ADDENDUM #6

TO THE CONTRACT DOCUMENTS FOR THE CITY OF PALM BAY

IFB # 39-0-2020/JG, South Regional Water Reclamation Facility Construction

Pipe Penetration Through Hollowcore Roof Panel

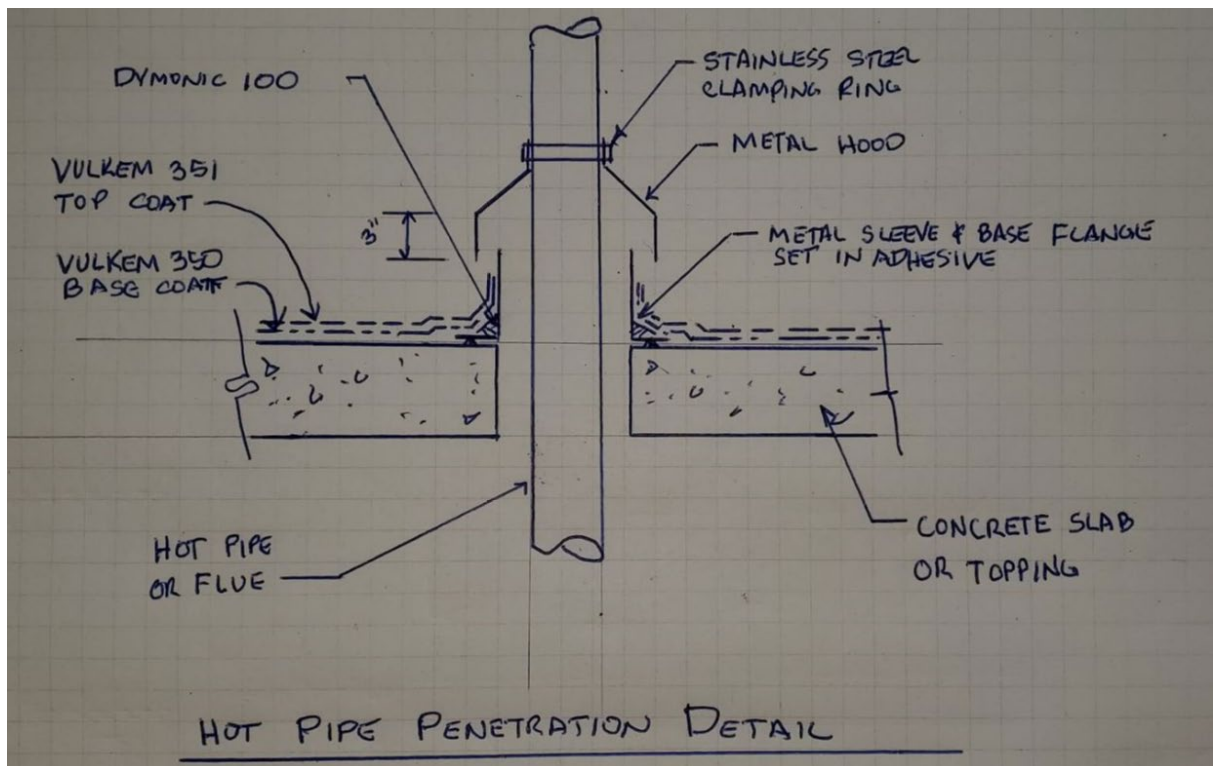
Q59. Drawing P-14 has notes at the one (1) 10” and two (2) 8” Process Air penetrations through the roof that say “Penetrate up thru roof; seal around opening”. Please provide a detail showing the materials required to accommodate these high temperature piping penetrations through the precast hollowcore roof and roofing material and also the method to seal the penetrations at the roof. Please also provide a detail for the four (4) 3” PVC Clean In Place pipe penetrations through the precast hollowcore roof and roofing material.

A59. Concrete Roof Slab (Concrete topping over 6” hollowcore plank) between building lines 1 to 3 and B to C, shall be covered with a traffic membrane consisting of a 25 mil base coat of Vulkem 350 and a top coat of 15 mils of Vulkem 351 by Tremco (or approved equal). See attached details for penetration details.

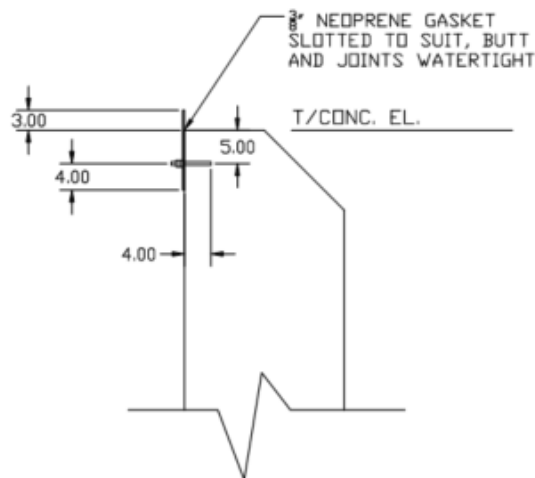
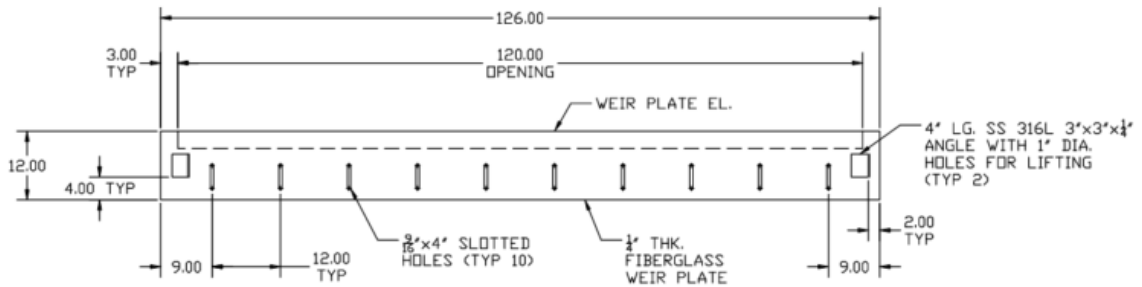
Q60. Sections 1 and 2 on Drawing P-11 show 10' Wide x 18" Tall (Adjustable) and 3' Wide x 8" Tall Weir Plates.

1. Please provide a specification for these weir plates, or at least indicate the required material (i.e. FRP, Stainless Steel, etc.)
2. Please provide details for connection of the weir plates to the concrete and

how to make the weir plate in Section 1 adjustable.

1. Weir plate shall be FRP. All requirements will be indicated on the supplied detail drawing below.
2. Refer to the connection detail below.

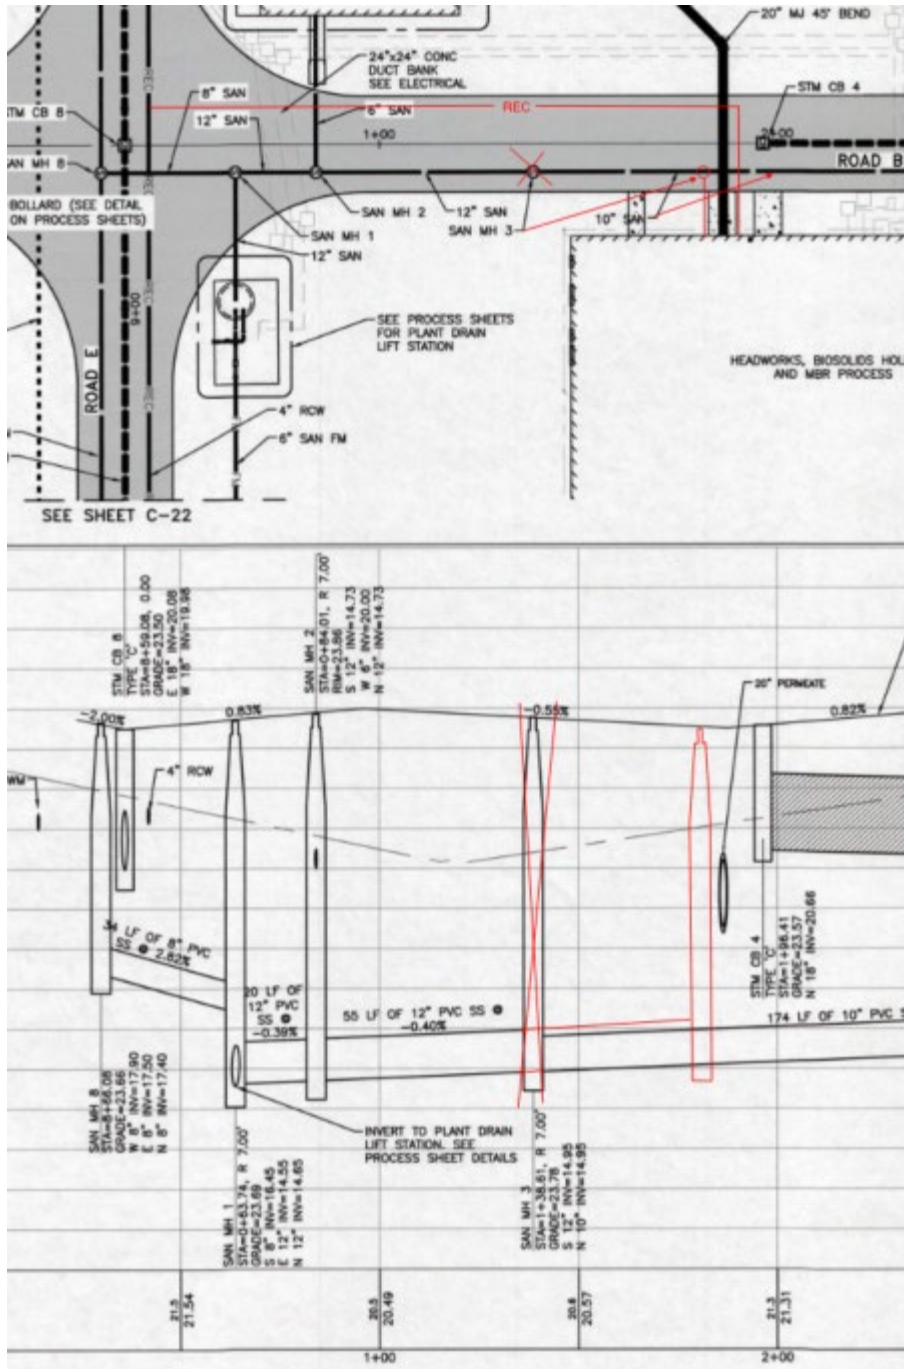
Q61. Note 1 on Drawing P-11 says “Provide automatic sampling equipment per specifications.” There is no other reference to automatic sampling equipment on this drawing. Does this note refer to the Influent Sampler shown on Drawings P-5 and I-4? Please confirm that the only automatic samplers required for this project are the influent sampler shown on Drawings P-5 and I-4, and the effluent sampler shown on Drawings P-18 and I-16.

A61. Only the Influent Sampler shown on drawings P-5 and I-4 and the Effluent Sampler shown on the drawings P-18 and I-16 are required.

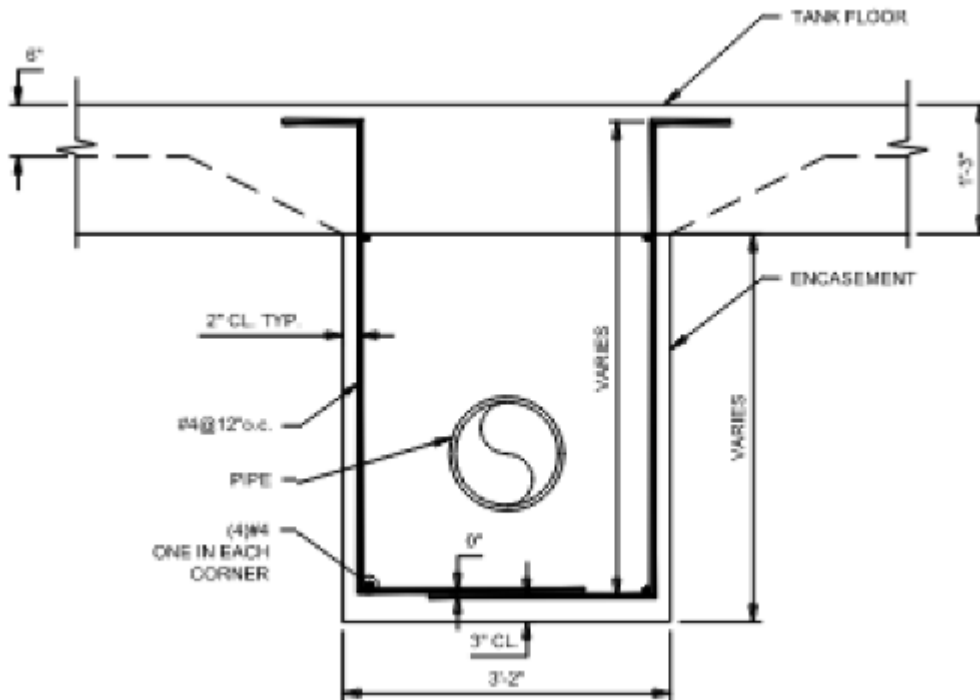
Q93. Reference Figure 8. on sheet C-34, it lists sizing for the concrete thrust blocks on the project. The chart shown includes pipe sizes 6”, 8”, 12” and 16”. Thrust restraints are required on the North and South side of the 20” Force main on sheet C-26.

Please provide thrust block size for 20” dia. Pipe.

A93. Per C-34, Figure 6, “IN LINE VALVES AND THROUGH RUN OF TEES OUTSIDE LIMITS OF RESTRAINED JOINTS FROM OTHER FITTINGS NEED NOT BE RESTRAINED UNLESS OTHERWISE INDICATED.”

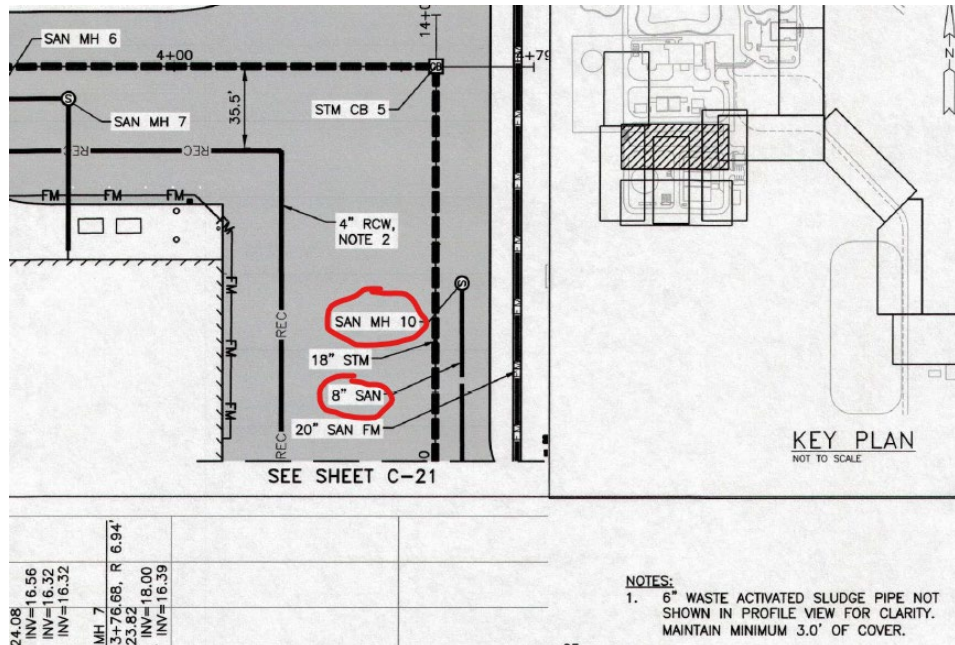
Q117. The proposed pond construction will end up with a huge (approx 130,000 cy) amount of excess fill. Should we figure hauling this off or stockpiling on-site?

A117. Per Addendum 4, the City has no desire to stockpile excess fill for future use. Additionally, the City has recently confirmed there are no immediate needs from our local partners; therefore, the Contractor shall be responsible for disposing all excess fill from the Site.

Note that the anticipated net cut amount is 80,000 CY: approximately 89,000 CY of cut and 9,000 CY of fill.

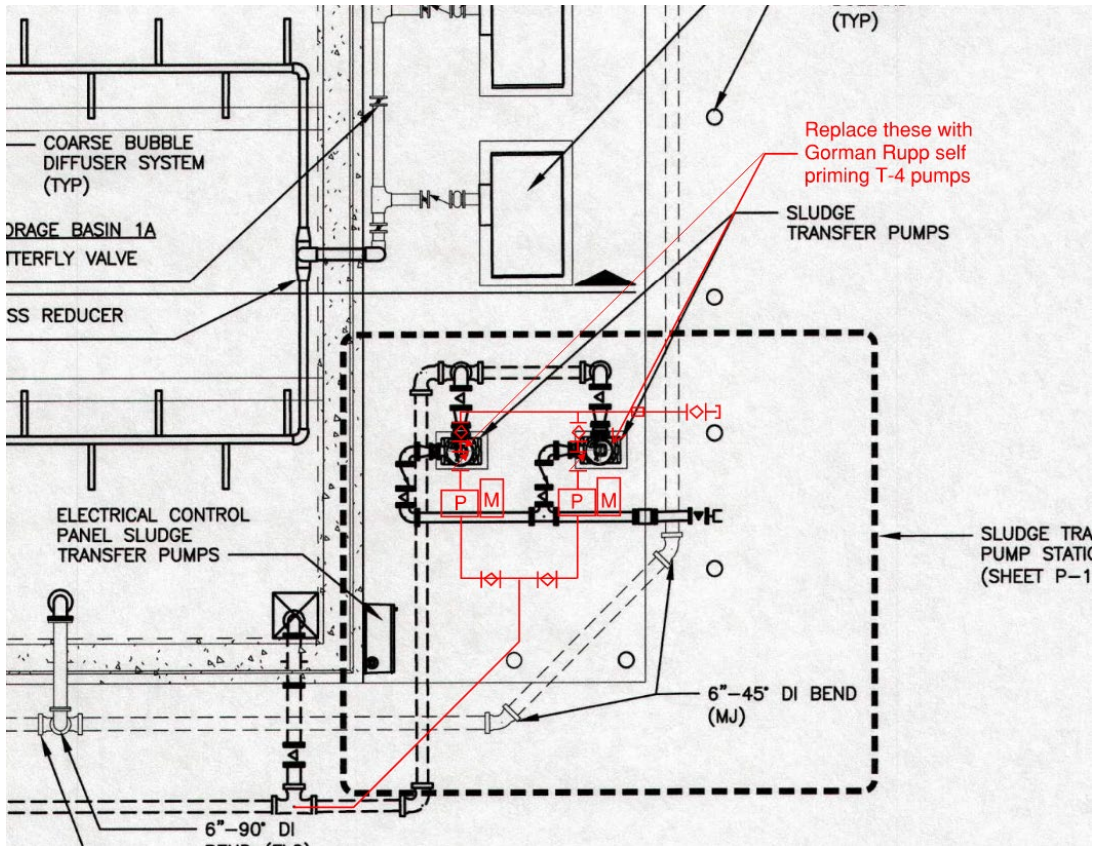
Clarification - Sludge Transfer pump modifications:

Section 11220 will be modified to include the following under Part 3.07.A.4:

4. Waste Activated Sludge (WAS) Transfer Pumps

Number	2
Tag	PMP-190101A; 190101B
Flow / Head	
Point 1	300 gpm @ 30 ft TDH
RPM	1150
Motor Size	7.5 HP
Suction Connection	4-in
Discharge Connection	4-in
VFD	NO
Pumped Fluid	Waste Activated Sludge

Piping to be rerouted as shown in the below mark-ups:
